Subject: Response to Portion of NRC RAI Letter No. 323 Related to ESBWR Design Certification Application – DCD Tier 2 Section 3.8 – Seismic Category I Structures; RAI Number 3.8-96 S04

**Partial Response to NRC RAI Letter No. 323
Related to ESBWR Design Certification Application¹**

DCD Tier 2 Section 3.8 – Seismic Category I Structures

RAI Number 3.8-96 S04

Figure 3.8-96(4) Coefficient as a Function of Poisson's Ratio

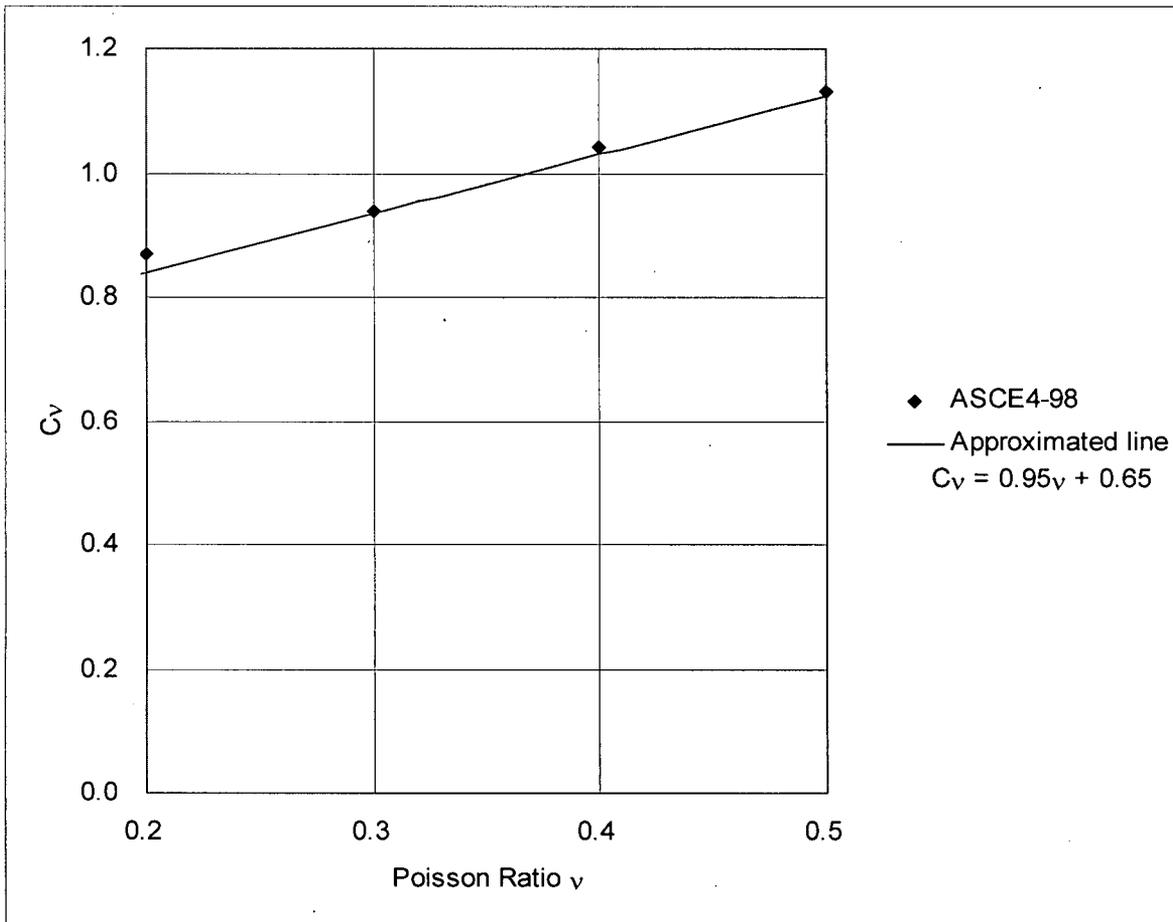
In the same section, GEH also provides the following recommendation: "To ensure the wall design seismic lateral pressures induced from backfill are not exceeded, a COL item will be added in DCD Tier 2 Table 2.0-1 to limit the product of peak ground acceleration (α) of the site-specific Foundation Input Response Spectra (FIRS) in g's, Poisson's ratio (ν) and density (γ) as follows: α ($0.95\nu + 0.65$) γ : 1220 kg/m³ (76 lbf/ft³) maximum." Provide an explanation and the basis for this recommendation.

The seismic lateral pressure limit, $\alpha (0.95\nu + 0.65) \gamma$, is derived from the resultant force F_r equation in ASCE 4-98, Figure 3.5-2, as follows:

- α : horizontal earthquake acceleration (g)
- γ : soil unit weight
- H : embedment height
- C_v : coefficient as a function of Poisson's ratio, ν . A numerical analysis of this equation shows that C_v , the coefficient as a function of Poisson's ratio, can be approximated by a straight line, $0.95\nu + 0.65$, as shown in Figure 3.8-96(4).
